City of Keene Planning Board

AGENDA

PB-2025-18, MOD. 1 – SITE PLAN REVIEW – CHARITABLE GAMING EXTERIOR MODIFICATIONS, 109-147 KEY ROAD

RE: PB-2025-18, Mod. 1
109-147 Key Road Site Plan Review Response
Fuss & O'Neill Reference No. 20250018.000

Figure 2. Snippets of the existing and proposed elevations for the north (main) façade of the barn being renovated.

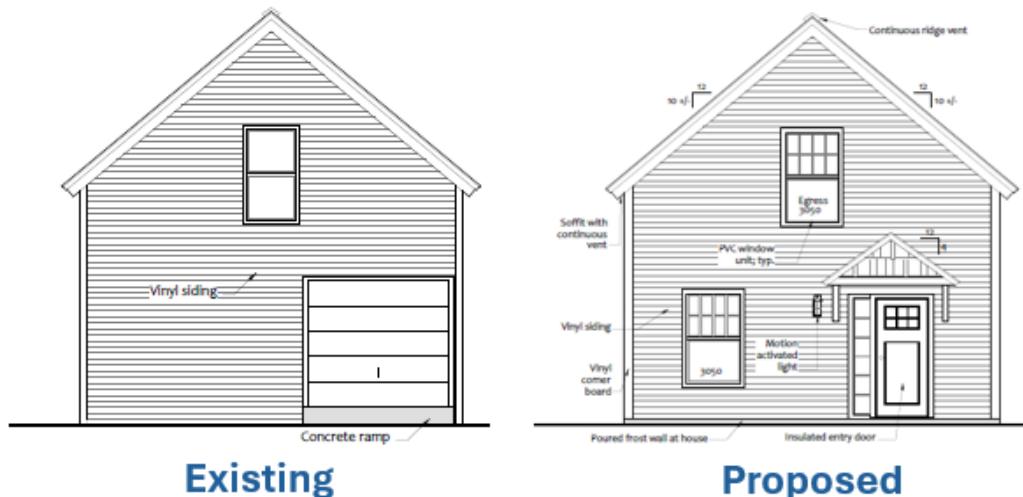
- G. **Architectural Guidelines:** The project narrative states that the existing wood-framed barn will be modified to have an exterior appearance that is consistent with the surrounding neighborhood. The existing elevations on Sheet A2 of the plan set show that the barn is currently finished with sage green vinyl siding and an asphalt shingle roof. The front (north) façade has a single garage door opening with a second-floor window. The proposed elevations on this same sheet show that the proposed renovations include the relocation and installation of additional windows and the addition of a new covered entry door with a sidelight (Figure 2). This standard appears to be met.

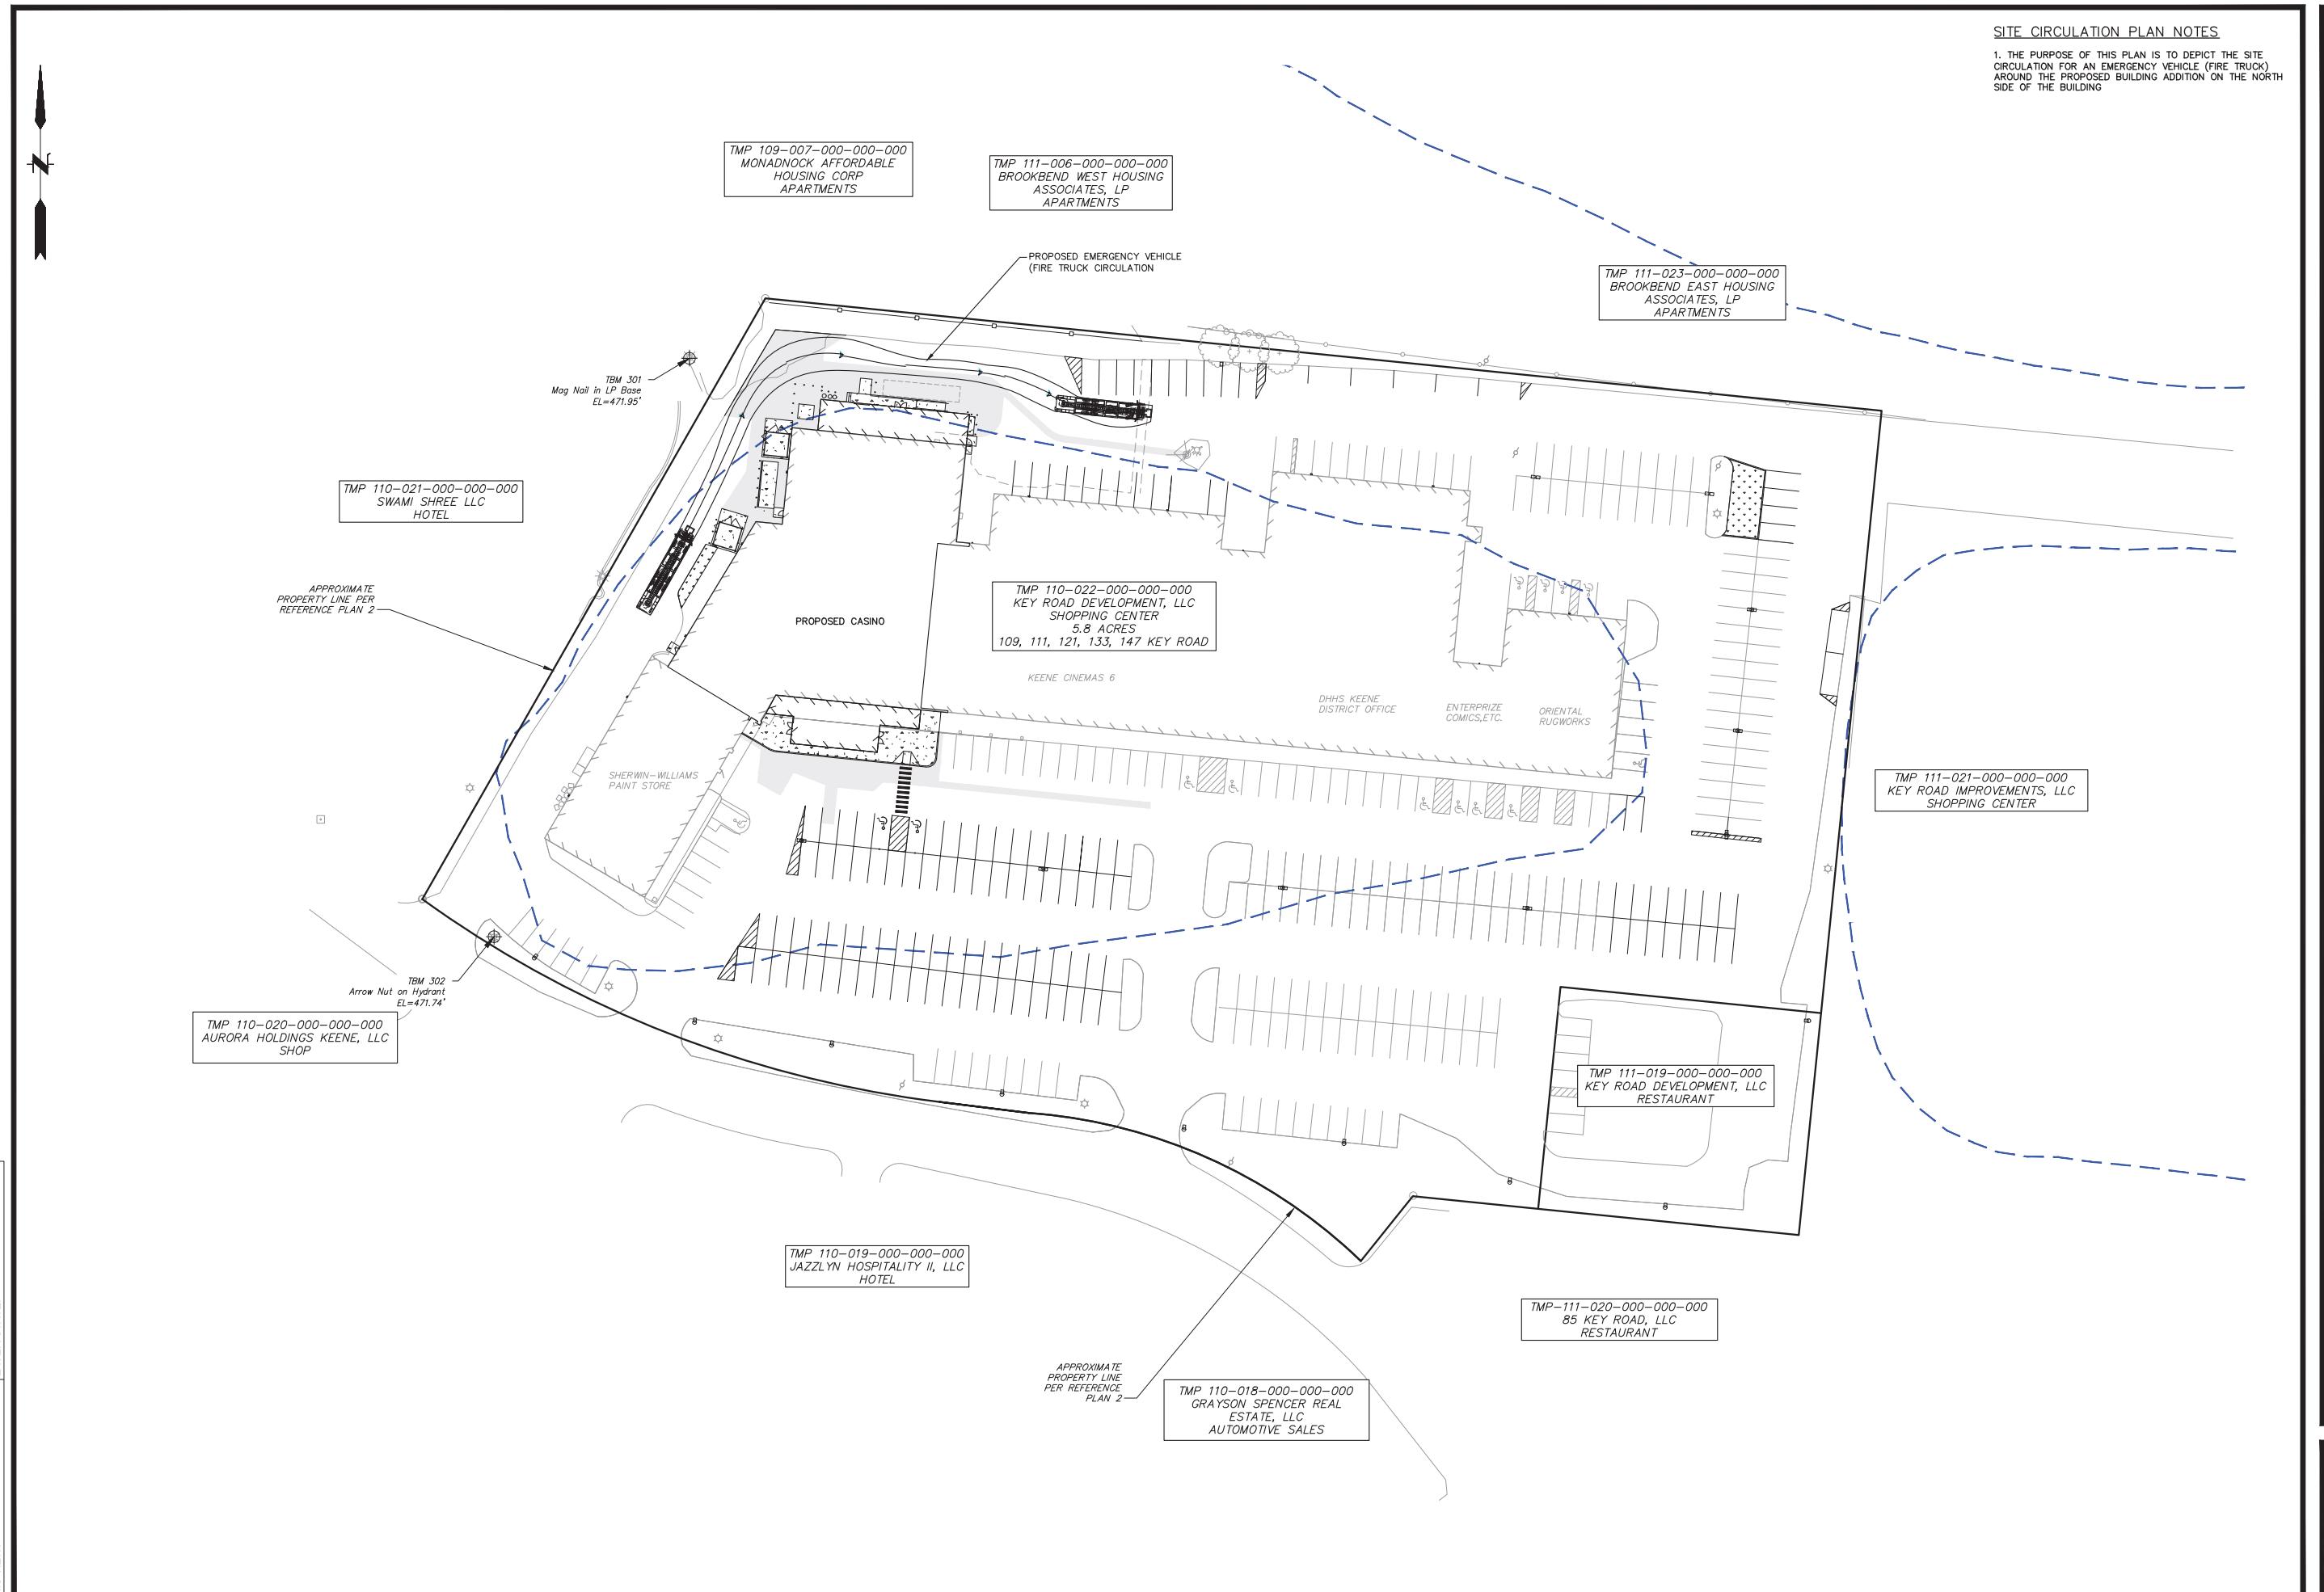
1. Lighting Plans: The lighting standard for hours of operation, section 21.7.3.F allows for normal illumination 1-hour before and after operating time. Outside those hours, only security lighting is permitted. For 24-hour businesses, light levels must be reduced by 50% between the hours of 10:00 pm and 6:00 a.m. These lighting standards apply for each use in the plaza, including the parking areas.

21.7.3.F.1.a states, "Security lighting, provided the average illumination on the ground or on any vertical surface does not exceed 1-footcandle." Therefore, security lighting is proposed from 2am to 7am Sunday to Thursday and 3am to 7am, Friday and Saturday. Drawing CL-102 shows the security level lighting where the average illumination does not exceed 1-footcandle.

A full-lighting plan and a reduced (50%) lighting plan were submitted with this application.

FO Response: There are no 24-hour businesses on the site.
